FIRST HILL APARTMENTS

1320 University Street, Seattle, WA 98101

RECOMMENDATION MEETING
November 16, 2016
PROJECTS #3022715

RESPONSE TO GUIDELINES: AXON OF PROJECT SITE LOOKING FROM SE CORNER

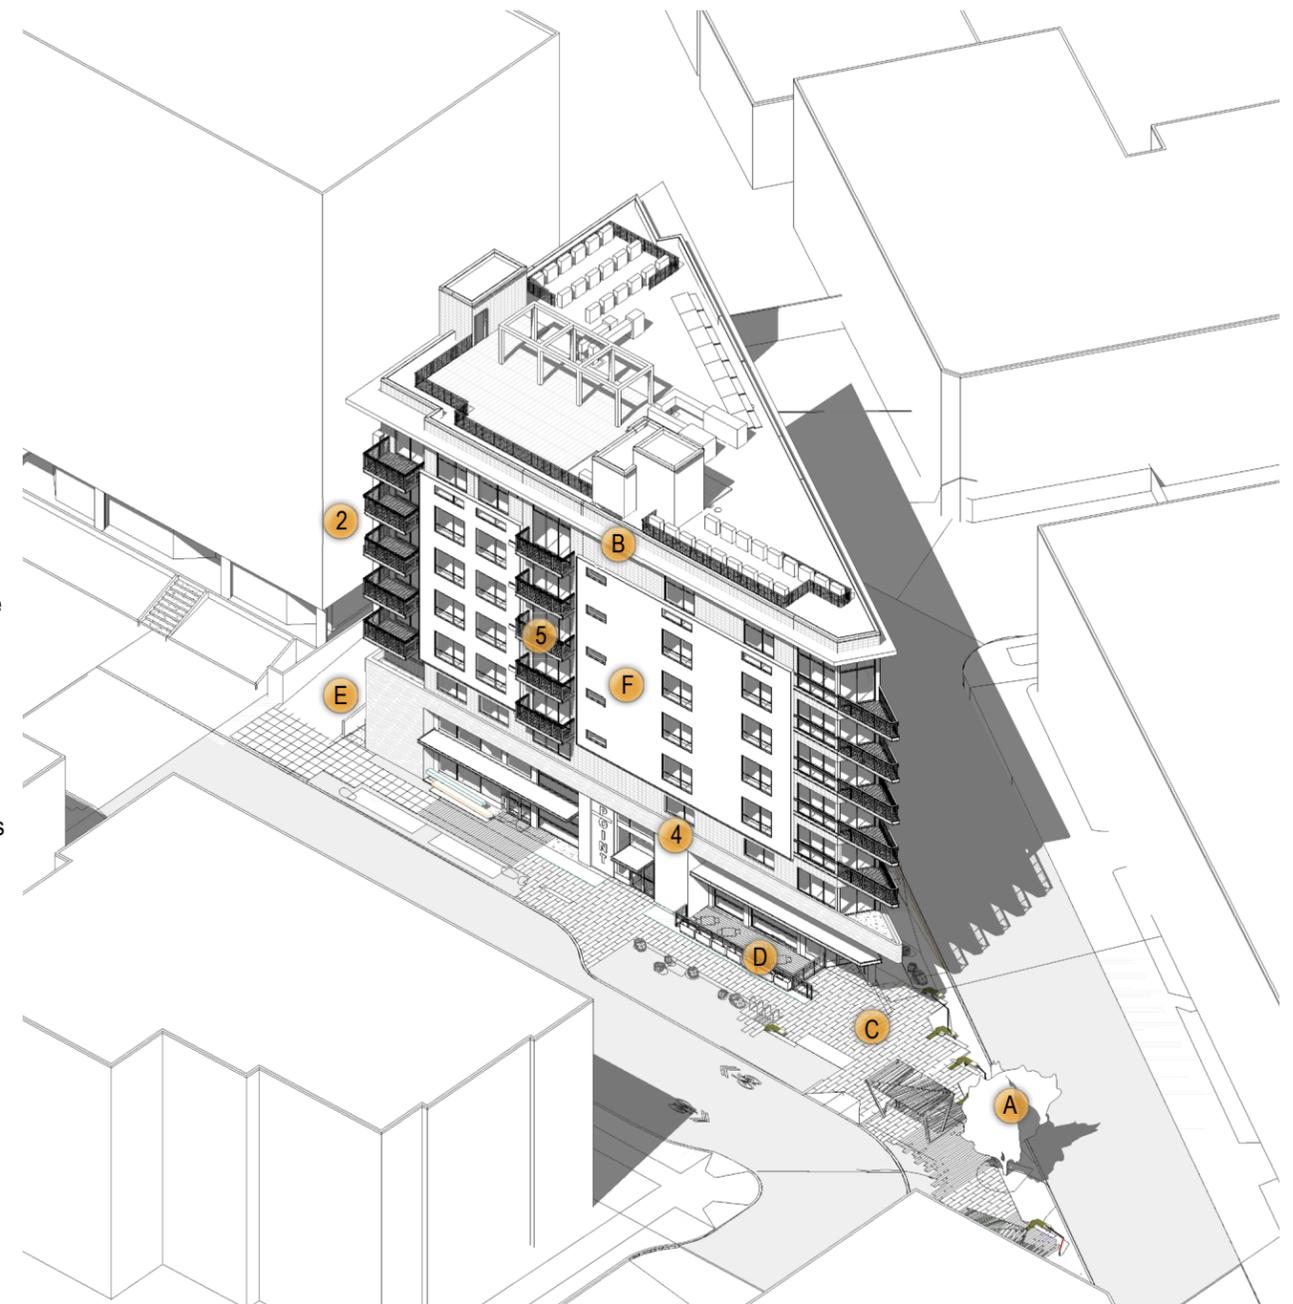
BOARD COMMENT (EXCEPTIONAL TREE): The Board unanimously expressed preliminary support for removal of the Exceptional Tree granted provided that Landscape/hardscape along the sidewalks and adjacent related pocket-park are well integrated into the site design and developed simultaneously with the building.

BOARD COMMENT (HEIGHT/BULK/SCALE & MASSING): The Board expressed preliminary support for preferred massing option, as the preferred option reduces the height to create further compatibility with the surrounding neighborhood. The Board discussed the importance of designing a highly transparent ground floor to create a visual connection to the public realm and reducing the perceived bulk at the ground floor level as well as creating "eyes on the street" and adjacent park. The Board stressed the importance of applying secondary architectural detailing in combination with the fenestration and windows to add depth and articulate the façade above the ground. The Board noted many of the buildings in the surrounding area are built to the property line or with minimal setback. Although the Board acknowledges contribution of the massing to the creation of a strong street edge, the requested departures warranted further discussion to ensure the bulk and scale of the proposed massing would be compatible with the context.

BOARD COMMENT (LANDSCAPE/POCKET PARK): The Board supported an integrated design between the building, sidewalk, and park; blurring the public and private spaces. A majority of the Board expressed enthusiasm related to development of park. However, the Board had the following concerns regarding the park design: Maintain the perception of the park as public. Select park furniture and overhead coverings. Specifically, that large overhead canopies may not be appropriate at this park site as it relates to safety and security. Create a clear and functional bike path connection. Compensate for the removal of the Exceptional Tree by planting a significant tree within the park space.

BOARD COMMENT (STREET LEVEL): The Board was pleased with the early direction of the street level design and emphasized the importance of: Highly transparent and porous retail/commercial edge. Maintaining floor to ceiling glazing as the project proceeds to create a perceived setback and blurring public/private space. Providing overhangs along both streets to further enhance the building's connection to the public space. Opportunities for smaller retail/commercial spaces, as well as a larger restaurant, to further activate the retail/commercial edge i.e. walk-up window opportunities. The Board further discussed supporting the ground floor departure as it relates to the building's surrounding context, noting many of the buildings within the surrounding context are built up to the property line.

A RESPONSE: Project proposes a cohesive landscape scheme to integrate the project site into neighboring sidewalk ROW along Union and University as well as the planned pocket park. Methods include attention to hardscape transitions at building entry points and landscape design for the pocket park occurring in conjunction with the proposed development. Project proposes to plant a large canopy tree to mitigate for the removal of the exceptional tree as well as to provide shading for the park.

B RESPONSE: The project creates a variety of glazing operability and floor to ceiling glazing locations along the majority of the street level facades. At the ground level, the variety of glazing types give detail to the facades where glazing is present. Project proposes awnings that will be at a pedestrian scale and integrated into the glazing mullion divisions. Awnings proposed at retail locations vary from the residential entry point overhang to bring unique character to the different building functions. Solid areas of the façade propose a mix broadform concrete and corten panels, materials with rich character and shadow relief potential. For the tower facades, project proposes a large format brick tile and corten panels. Walls with varied materials will be offset from each other by at least their wall depth to create strong shadowlines on the façade and provide a reduced sense of scale in the overall

massing. All units, except for the second floor, will have access to private decks. These decks create additional depth to the façade articulation, create strong corner gestures for the massing while still creating corner insets for massing relief, and are placed to emphasize material transitions.

C RESPONSE: Project team proposes the following for the pocket park: The space will be open to public at all times. A variety of site furnishings will provide a variety of seating options as well as a open canopy structure. CPTED issues regarding sight lines will be addressed with all elements within the space. Bike path and greenway connections have been studied and coordinated with SDOT. A large canopy tree is proposed to mitigate for the removal of the exceptional tree as well as to provide shading for the park.

D RESPONSE: The amount of glazing area and variety of glazing operability opportunities has been retained and increased in the proposed design from the EDG proposal. Glazing height is proposed to be 17' in height along both University and Union. Project has increased the ground level floor to floor height in order to incorporate mezzanine opportunities within the retail spaces. (Commercial use at the mezzanine is a requested departure, please refer to departure diagrams). Project proposes awnings along the length of retail glazing locations. Along University, a 5'-0" deep awning is adjacent to the retail entry inset spaces at the covers the entire area of its massing recesses. Along Union, a 4'-6" deep awning occurs at each glazing location for a total of 70 feet of facade length. Additional awnings are present at the residential tower entry and the parking garage entry. The retail space is configured to divide the space into two distinct retail tenants, with one entry along University and the second at the intersection of University and Union. Due to the ground level massing recesses, the establishments may distinguish themselves from each other. Please refer to a neighborhood setback study included in this packet showing surrounding context precedence for building footprint holding strong connection to property lines.

PRIVACY STUDY

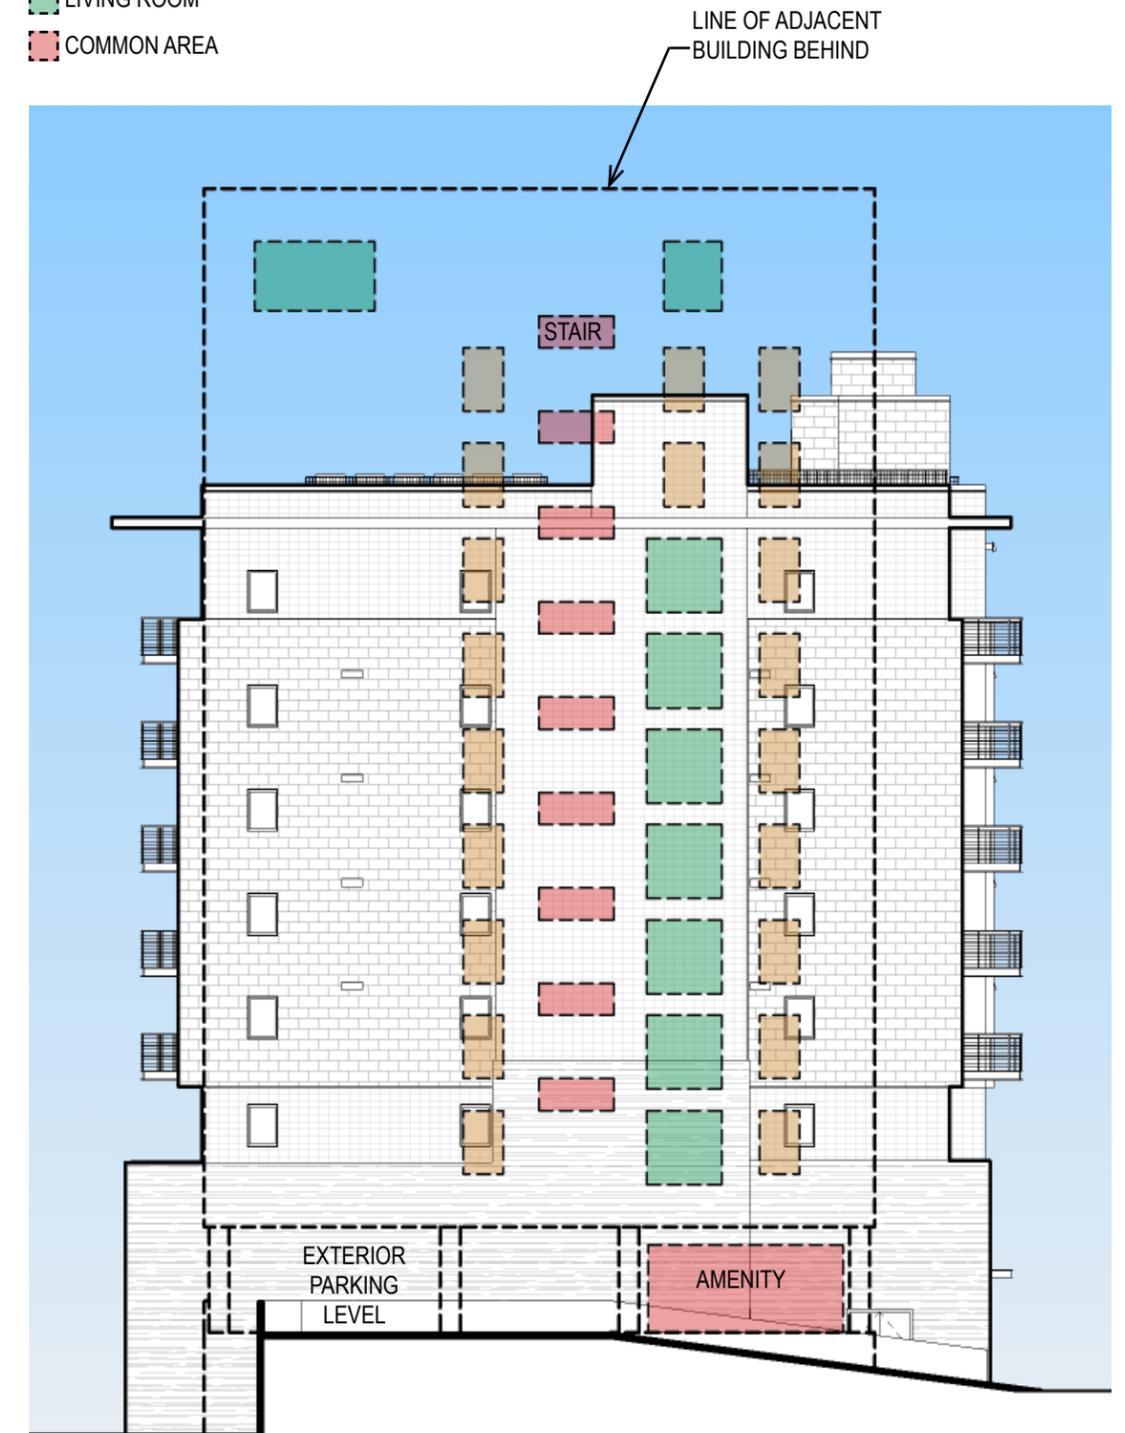
Reduced Side Setback: The board indicated preliminary support, however requested a fenestration / privacy study to understand impacts to the adjacent building

The existing facade of the adjacent building is overlaid on the West Elevation of the proposed building. Microfilm research for the existing building information as well as site photos were used to approximate the location of the windows in the adjacent facade. The windows are color coded to their function. The existing fenestrations of the adjacent buildings do not directly align with the privacy of the proposed building.

GROUND LEVEL PLAN ALONG WEST PROPERTY LINE

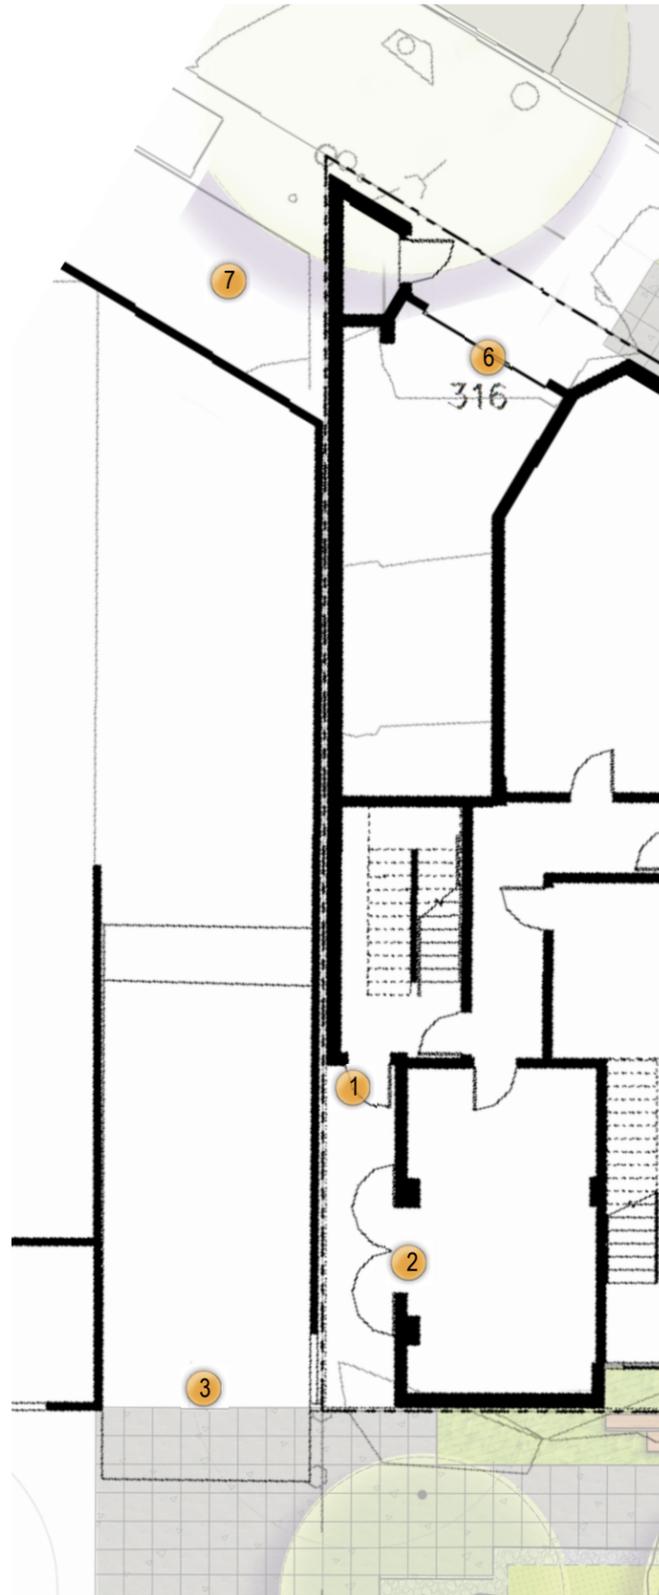
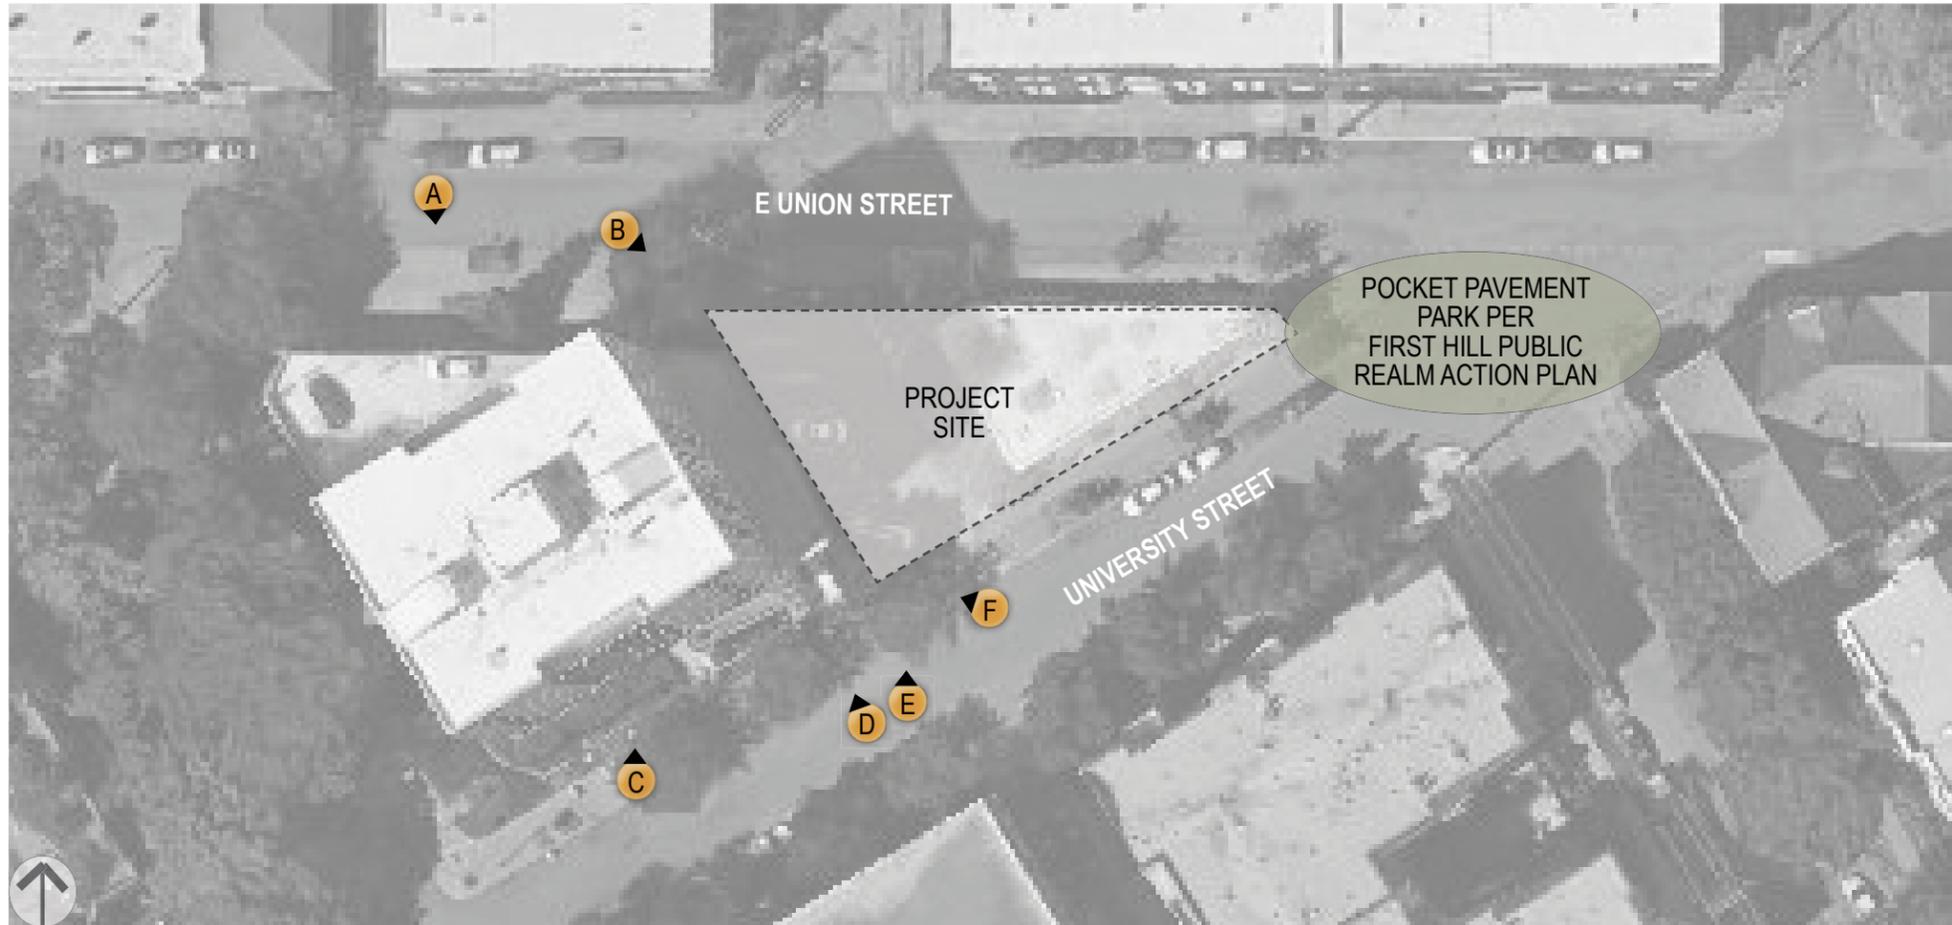
BOARD COMMENT (PARKING AND SERVICE USES): The Board unanimously agreed that the parking entrance along Union Street and service uses along University Street would need to be further resolved at the Recommendation meeting, especially as related to the departure. Analysis is required to understand the functionality and pedestrian experience, as well as, impacts to the façade design. The Board requested more information including character sketches, precedent images, and street level perspectives to better evaluate both the parking entry and location of service uses.

E RESPONSE: Service entries are placed adjacent to existing service entries on the lot to the west, placing them as far from the pedestrian access points and the current park as possible. The garage entry is recessed from the building facade, allowing the recess walls to "flare" to create greater visibility for drivers to see on coming pedestrians and vehicles while still limiting the impact of the parking use on the building facade. The recess and associated overhead canopy provide clues to pedestrian traffic that a driveway location is present. The refuse / recycle location abuts the adjacent building retaining wall and driveway ramp. This location provides the least impact to the public while maintaining the easiest access for haulers. The refuse / recycle room door is located along the interior lot line facing the existing retaining wall, limiting the impact of the service use on the streetscape by eliminating direct sidewalk access. Please refer to a parking & service entry study included in this

Service entries are designed to function adjacent to existing service entries on the lot to the west. This also places them as far from the pedestrian access points and the current park as possible. Due to site constraints from a triangular lot, the garage access is placed at the lowest elevation corner of the site, the northwest. Without garage access at this location, it is infeasible to provide parking to the site due to the amount of space the garage ramp would occupy. The garage entry is recessed from the building facade, allowing the recess walls to “flare” to create greater visibility for drivers to see on coming pedestrians and vehicles while still limiting the impact of the parking use on the building facade. The recess and associated overhead canopy provide clues to pedestrian traffic that a driveway location is present. On the southwest corner the refuse / recycle is proposed to abut the adjacent building retaining wall and driveway ramp. This location provides the least impact to the public while maintaining the easiest access for haulers. The refuse / recycle room doors are located along the interior lot line facing the existing retaining wall. This location limits the impact of the service use on the streetscape by eliminating direct street lot line access.
